**WHITLEY COUNTY ADVISORY PLAN COMMISSION
STAFF REPORT**

24-W-SUBD-7 PRIMARY PLAT APPROVAL

Troy Tracy
"Tracy Acres", 2825 W. 450 North

**APRIL 17, 2024
AGENDA ITEM: 1**

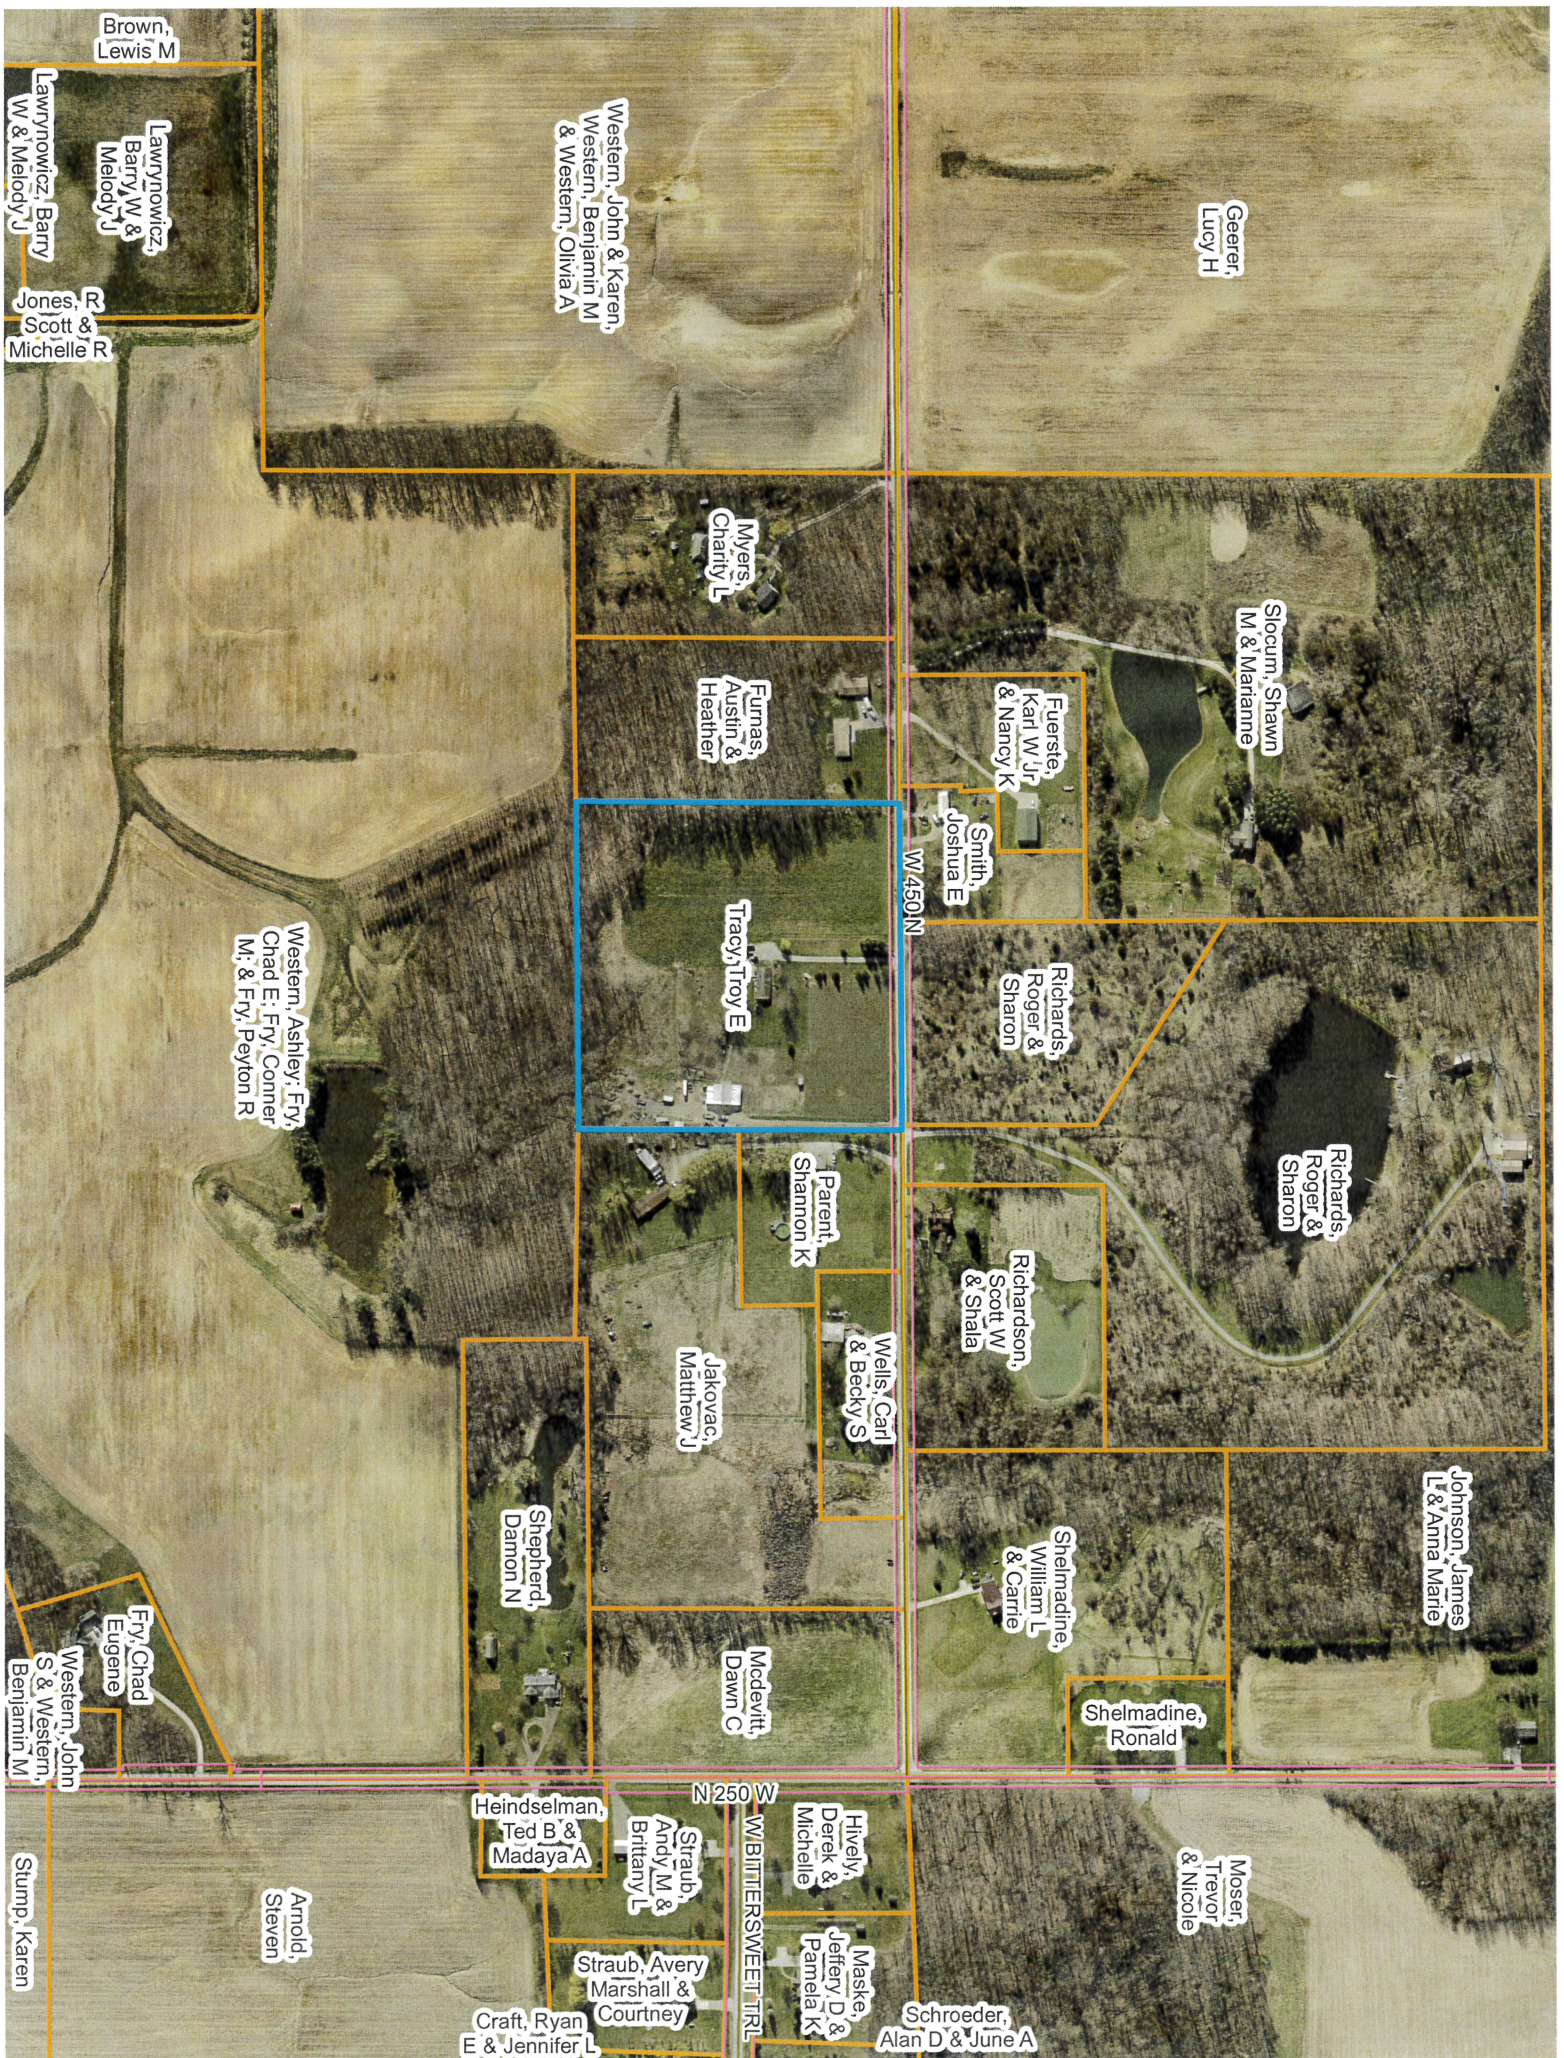
The County Engineer noted that driveways should be located farther east than the westernmost 50' of the property. Otherwise, he provided notes on the requirements for driveway permitting and construction.

The Parcel Committee noted that the owner name needed to be modified to match the recorded name, "Troy E. Tracy."

1. Two septic sites per lot are to be determined and approved by the Health Department prior to issuance of a building permit for a primary structure.
2. Correct owner name.
3. Add notation on plat that the driveways may not be located on the westernmost 50' of Lot 1.
4. Secondary plat approval delegated to the Plan Commission staff.
